SUNDRY NOTICES AND REPORTS ON WELLS
Do not use this form for proposals to drill or to re-enter an abandoned well. Use Form 3160-3 (APD) for such proposals.

| | | 9. API Well No. 30-089-35046 |

Huntington Energy, L.L.C. respectfully requests changes to the Casing and Cementing Program on the attached Operations Plan. The proposed changes are highlighted on the Operations Plan.

***REVISED 4/9/10

Figure #1

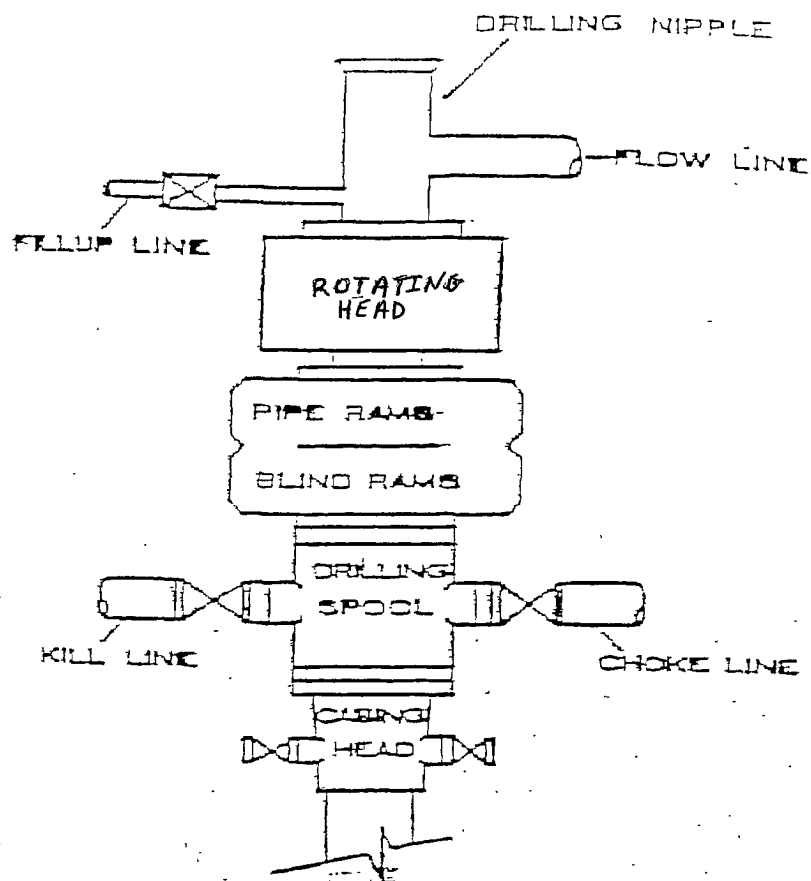
7 1/16" 2000 psi minimum double gate BOP stack. (Reference Figure 1). After nipple-up prior to drilling out surface casing, rams and casing will be tested to 600 psi for 30 minutes.

7 1/16" 3000 psi double gate BOP stack (Reference Figure #1). After nipple-up prior to completion, pipe rams, casing and liner top will be tested to 2000 psi for 15 minutes.
